AMENDMENT OF SOLICITATION/MODIFICATION OF CONTRACT				1. CONTRACT ID CODE J	PAGE OF PAGES 1 2
2. AMENDMENT/MODIFICATION NO. 0005		3. EFFECTIVE DATE 29 April 2004	4. REQUISITION/PURCHASE REQ. NO.	5. PROJECT NO. (If applicable)	
6. ISSUED BY U.S. ARMY ENGINEER DISTRICT, ALBUQUERQUE CORPS OF ENGINEERS 4101 JEFFERSON PLAZA, N.E. ALBUQUERQUE, NEW MEXICO 87109-3435		CODE	7. ADMINISTERED BY (If other than Item 6) CODE		
8. NAME AND ADDRESS OF CONTRACTOR (No., street, county, State and ZIP Code)			(<input checked="" type="checkbox"/>)	9A. AMENDMENT OF SOLICITATION NO. W912PP-04-R-0011	
			<input checked="" type="checkbox"/>	9B. DATED (SEE ITEM 11) 18 March 2004	
				10A. MODIFICATION OF CONTRACTS/ORDER NO.	
				10B. DATED (SEE ITEM 13)	
CODE		FACILITY CODE

PROJECT: DESIGN/BUILD, ARSENIC TREATMENT SYSTEMS, KIRTLAND AIR FORCE BASE, BERNALILLO COUNTY, NEW MEXICO

1. This is Amendment No. 5 to Solicitation No. W912PP-04-R-0011; 18 March 2004. The following revisions shall be incorporated into the specifications. All other provisions shall remain unchanged.

2. SPECIFICATIONS: Delete the following listed pages and substitute the pages attached hereto. On the revised pages, for convenience, cha

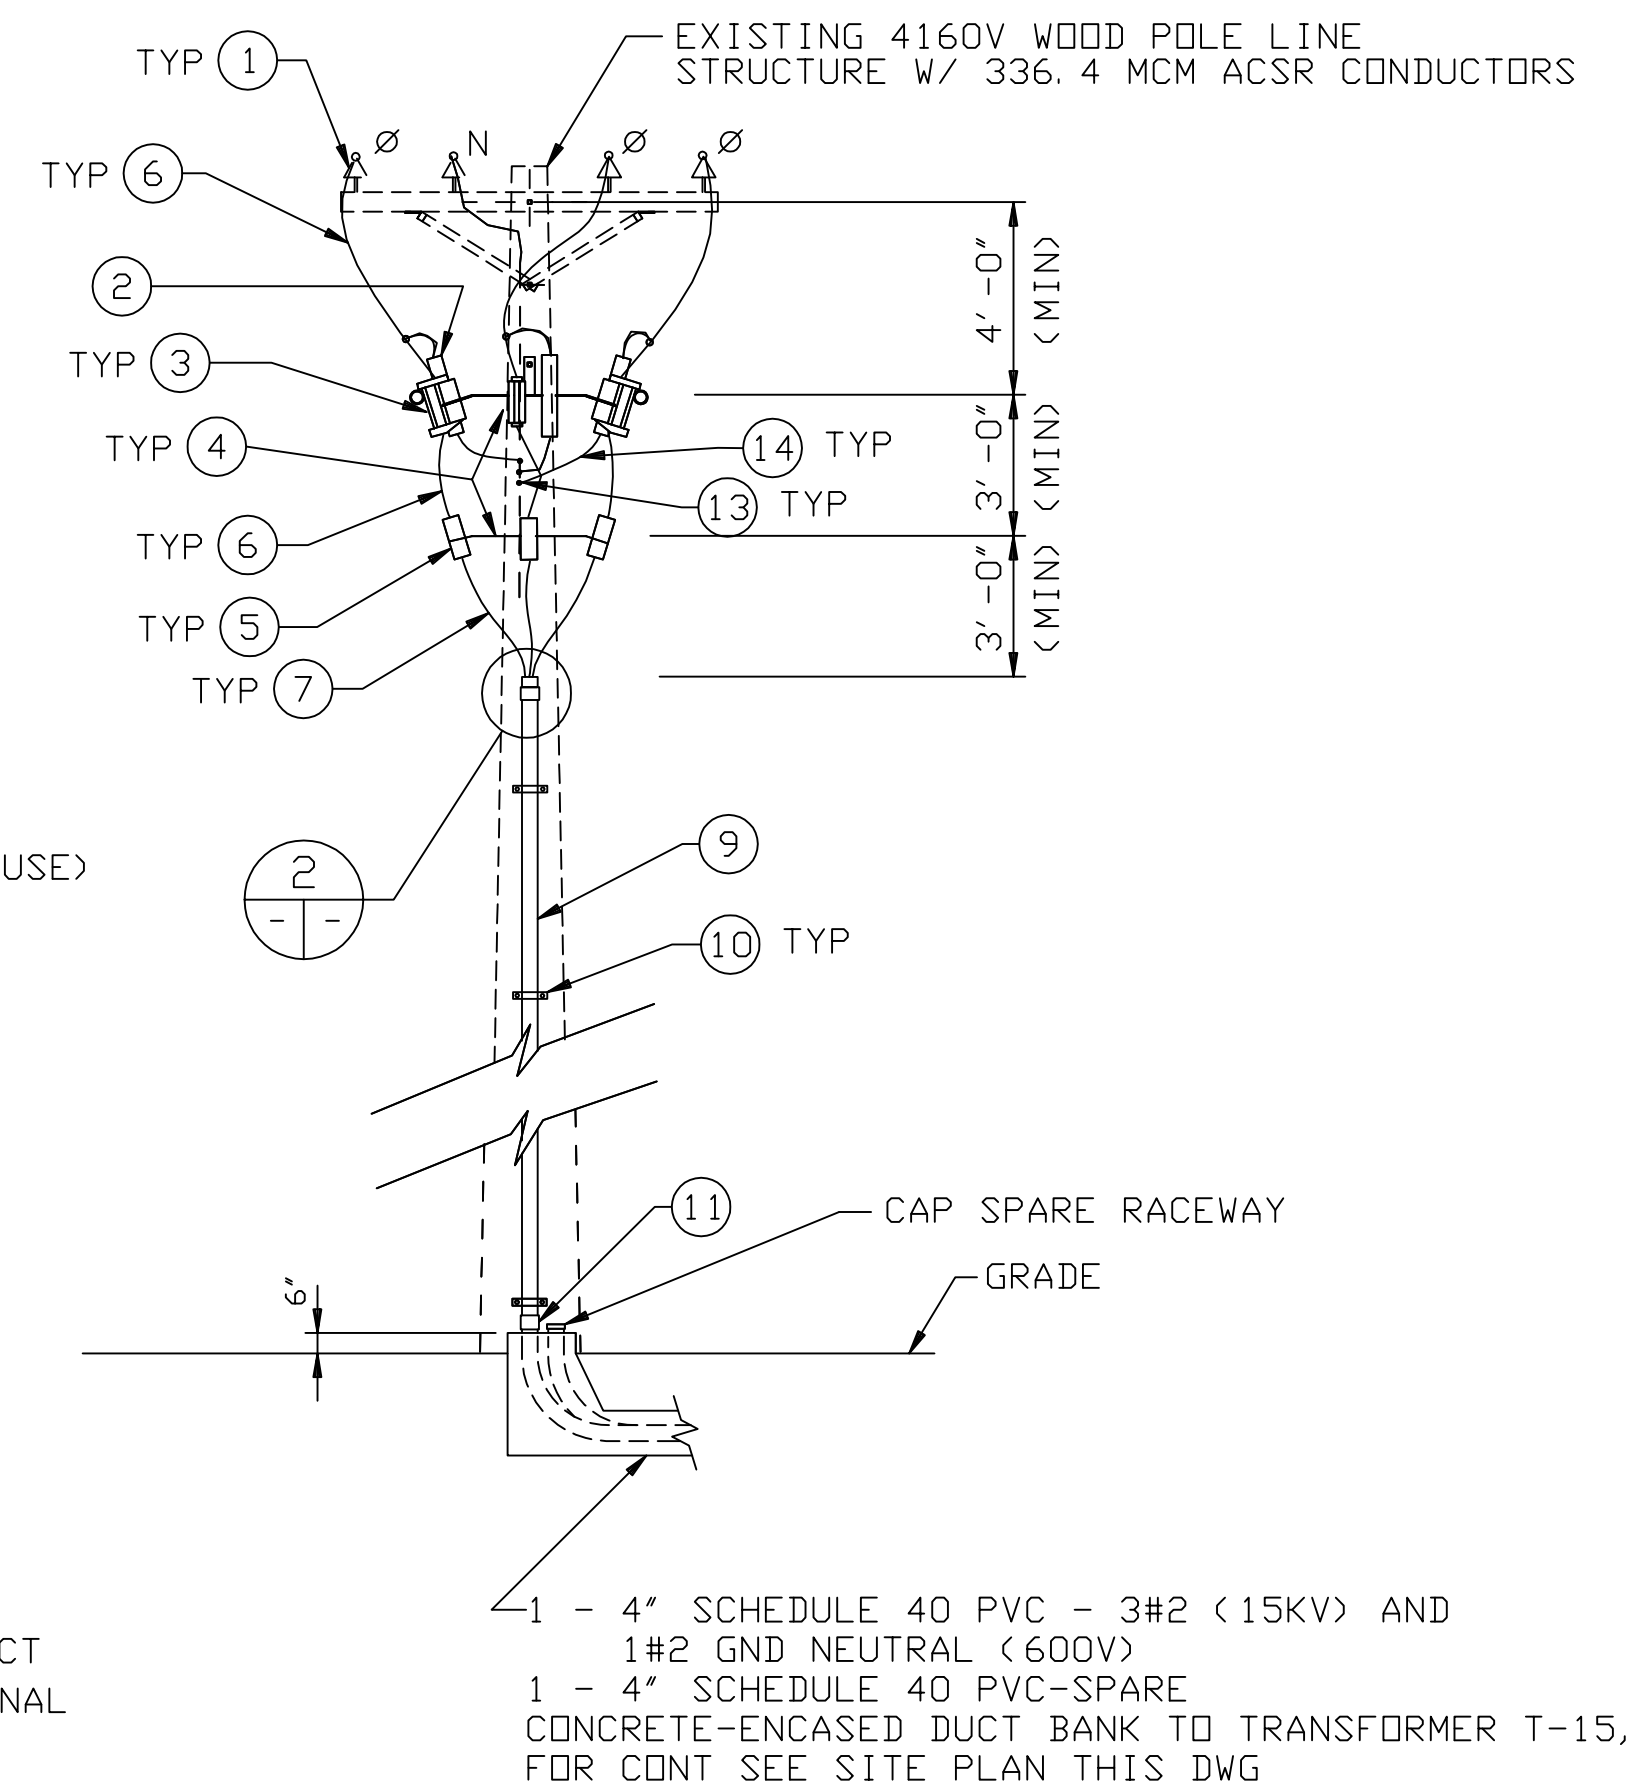
3.7.5 **Auxiliary Water Diversion Line.** The Contractor shall install an 18-inch auxiliary water diversion line as shown conceptually on Diagram 1 in Appendix N. This line will give Base water system operators additional flexibility in operating the system. The Contractor shall determine the optimal routing of this line.

WELL NO. 15 SITE PLAN

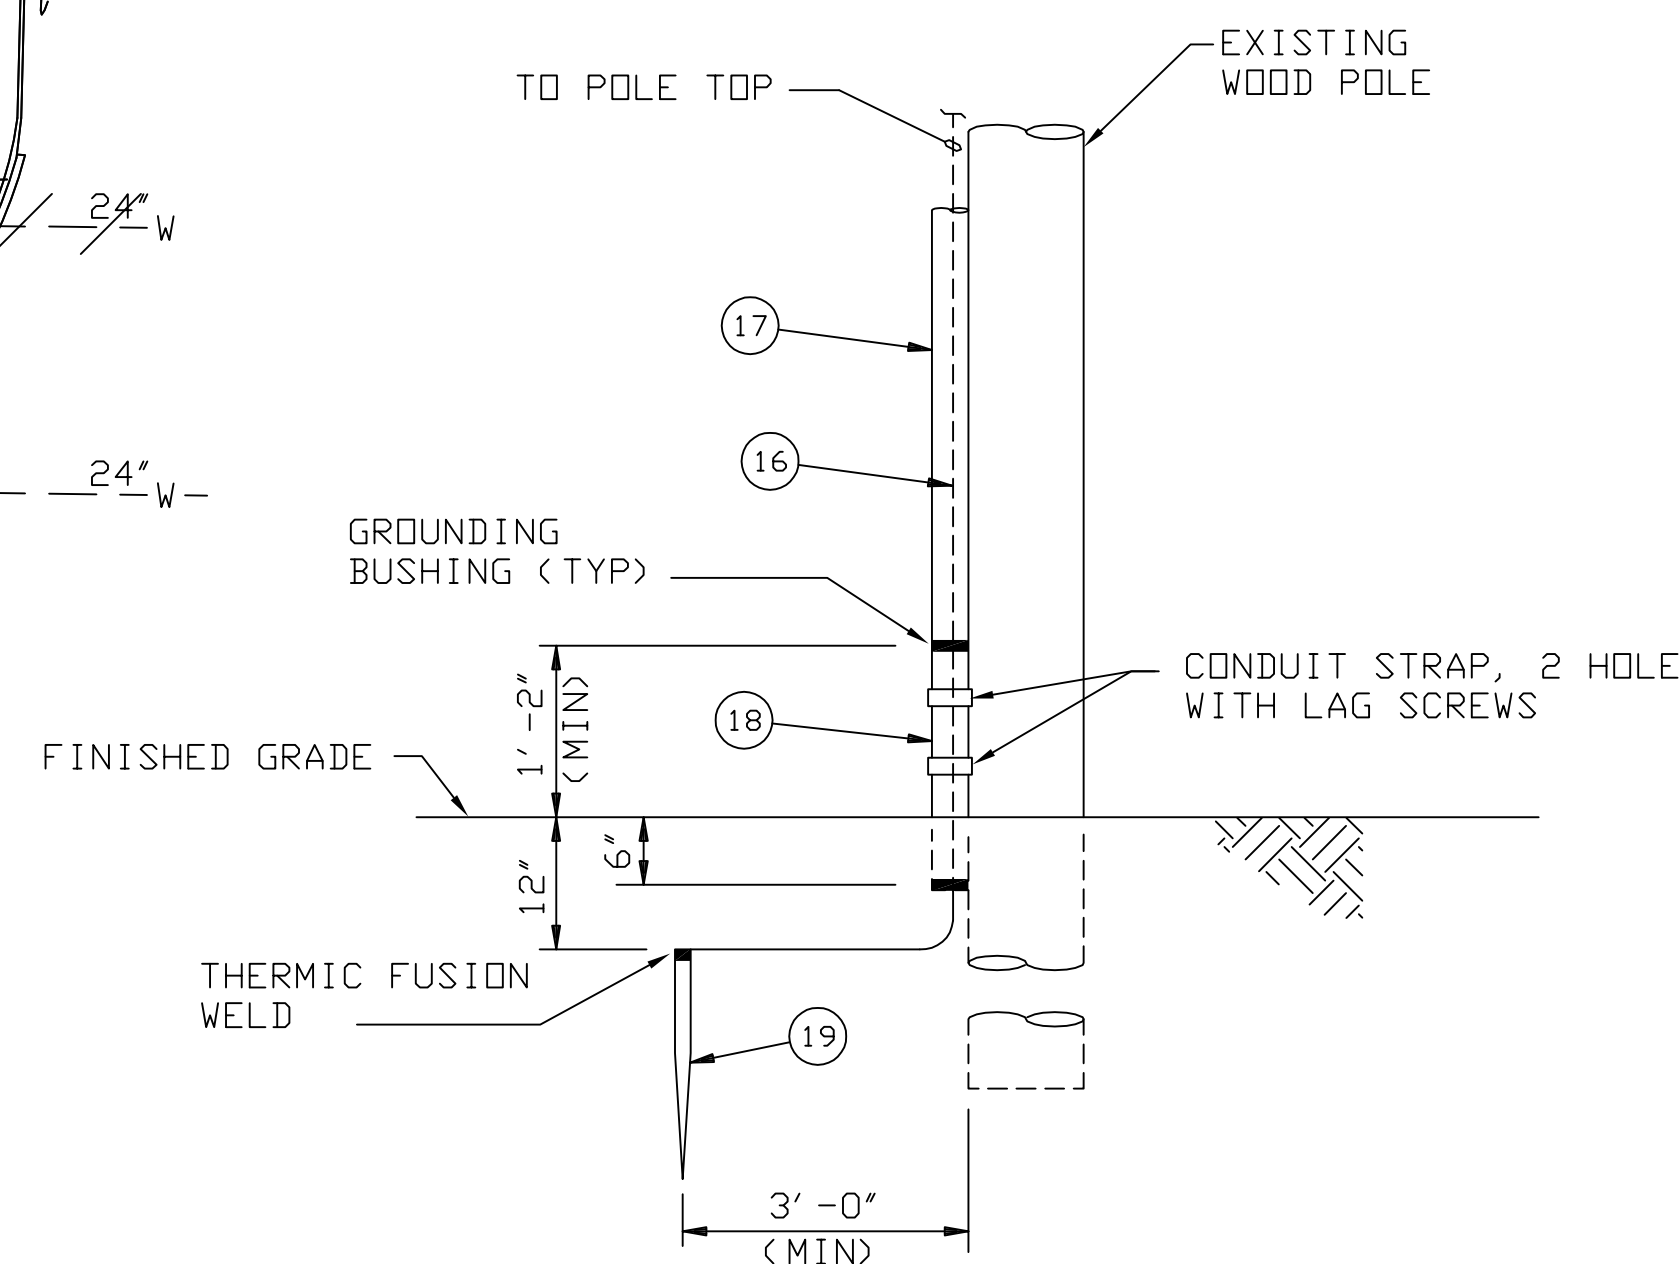
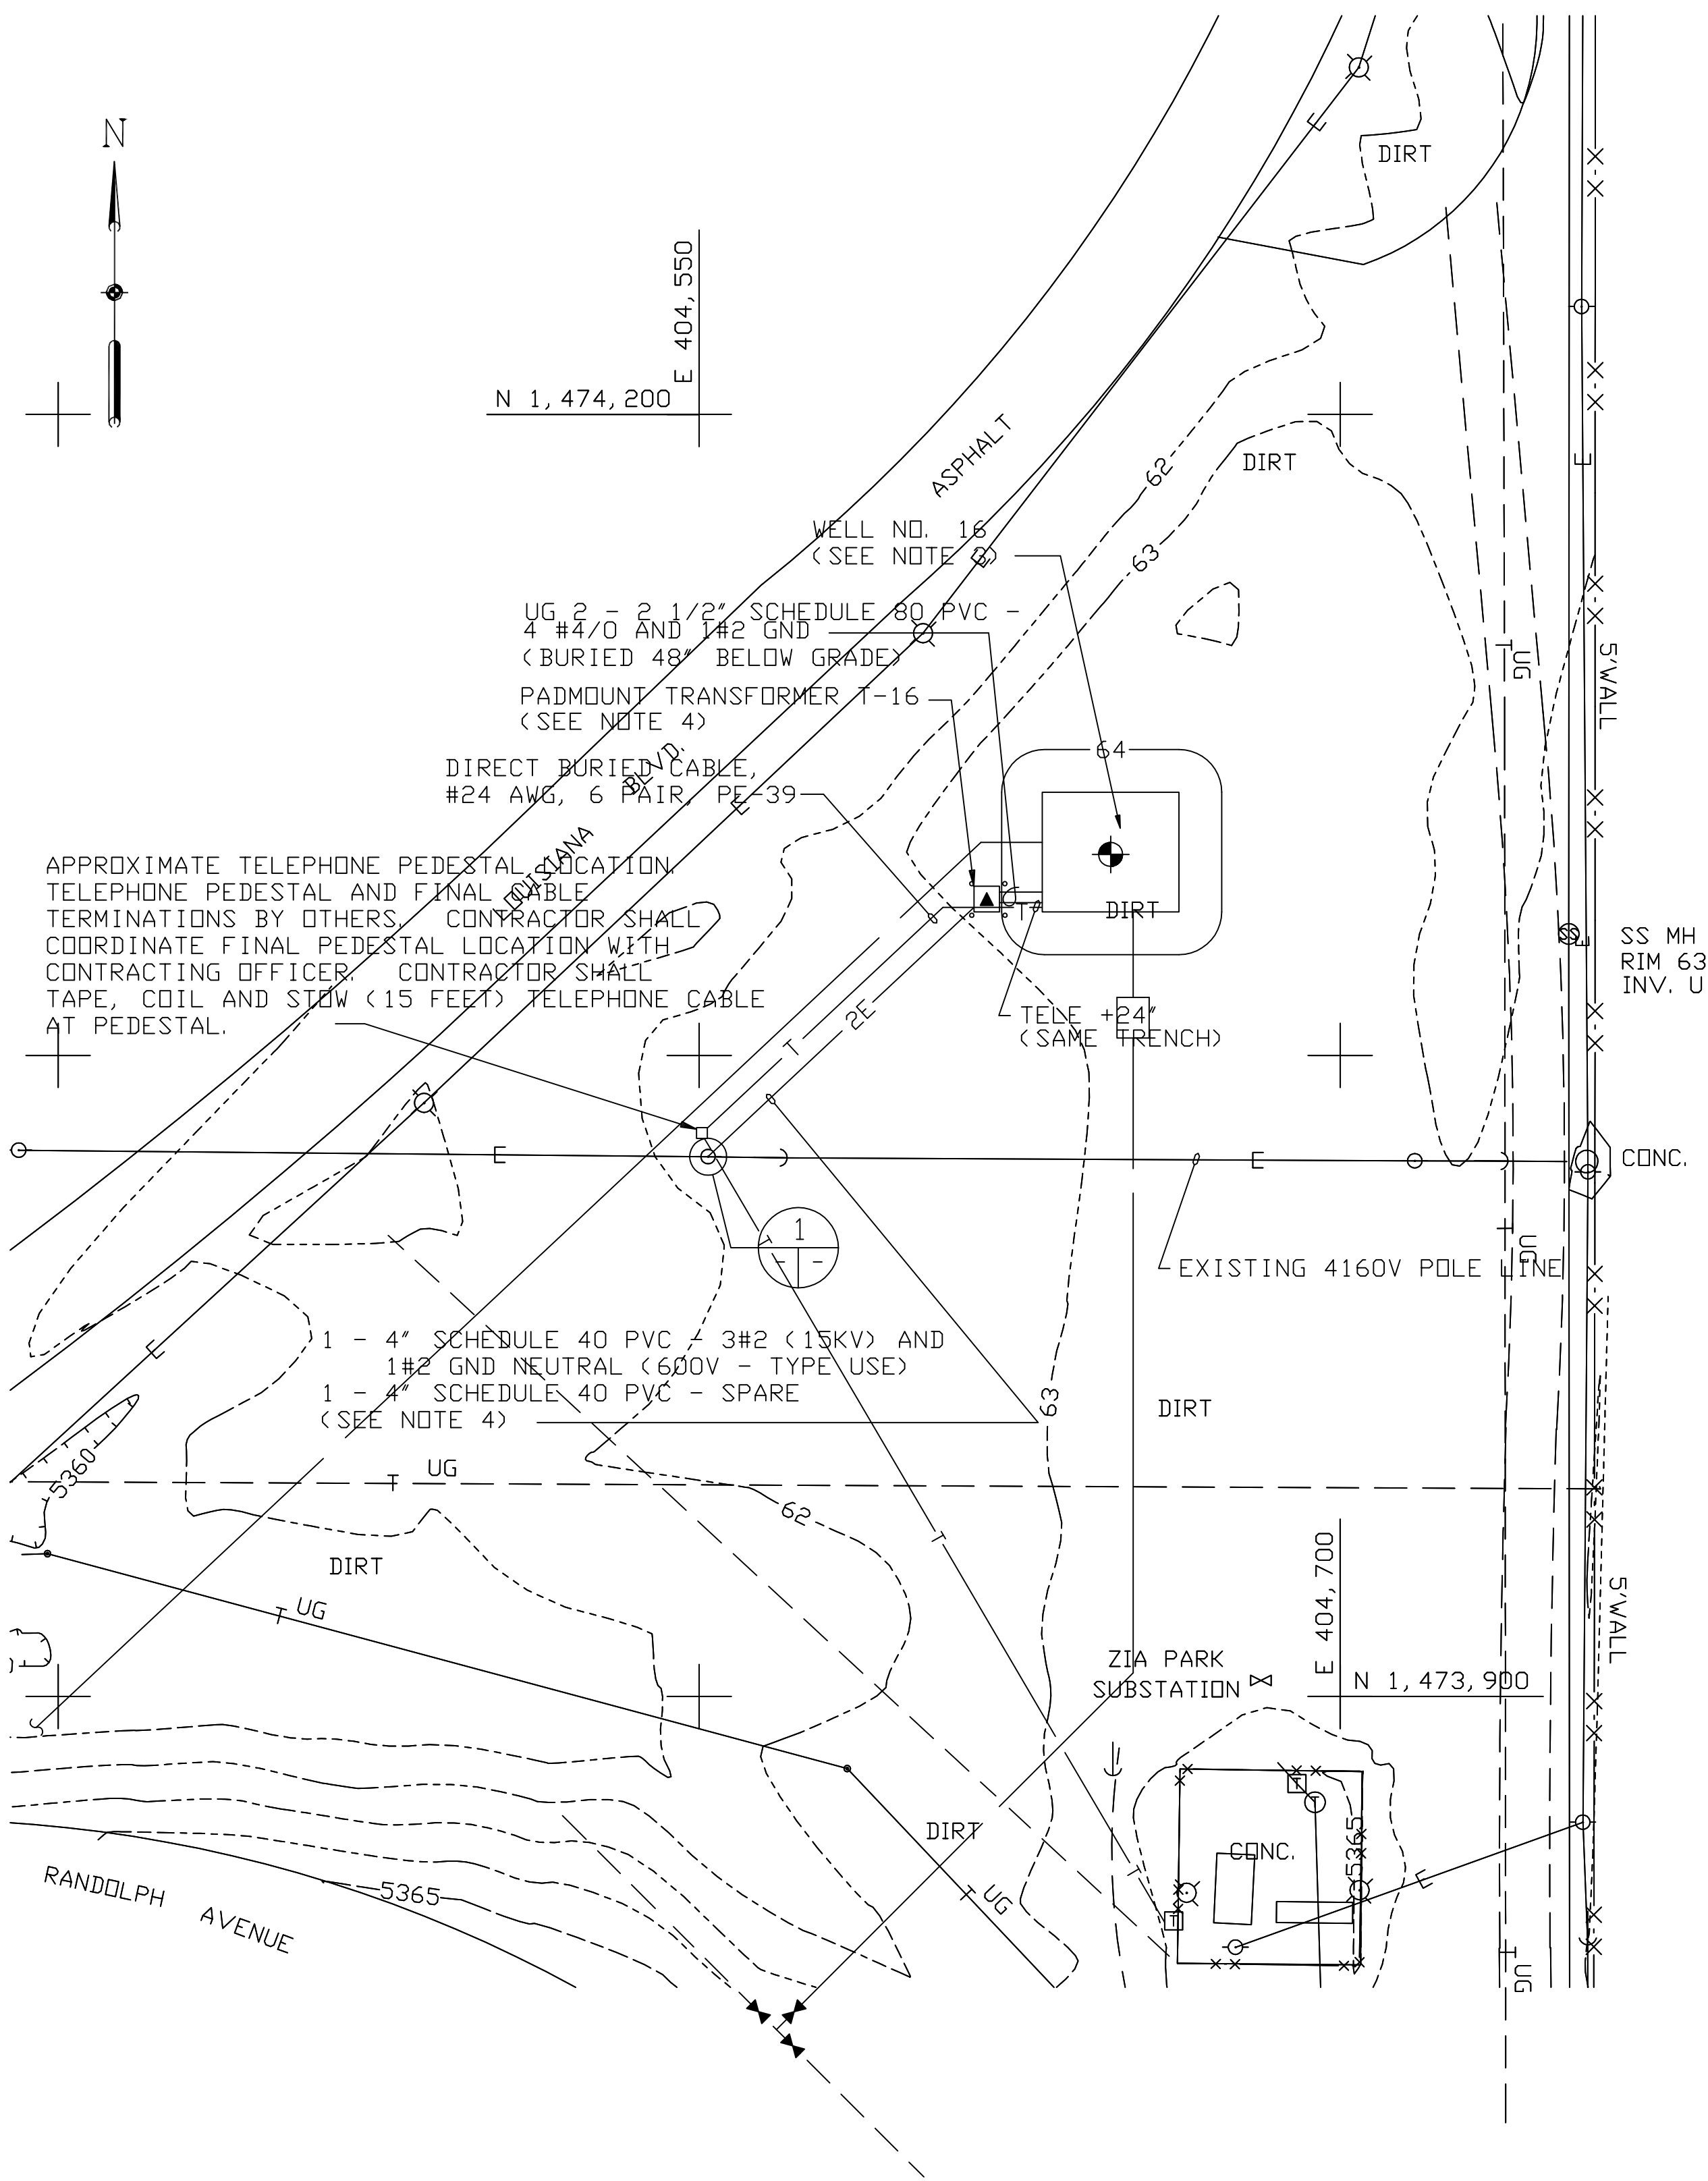
<u>Delete Page</u>	<u>Insert Page</u>
<u>Volume 1 of 3</u>	
01010-8	01010-8
01010-10 thru 01010-11	01010-10 thru 01010-11
01010-13b	01010-13b
<u>Volume 3 OF 3</u>	
Appendix N, Diagram 1	Appendix N, Diagram 1
Appendix N, Sequence No. 56	Appendix N, Sequence No. 56
Appendix N, Sequence No. 57	Appendix N, Sequence No. 57
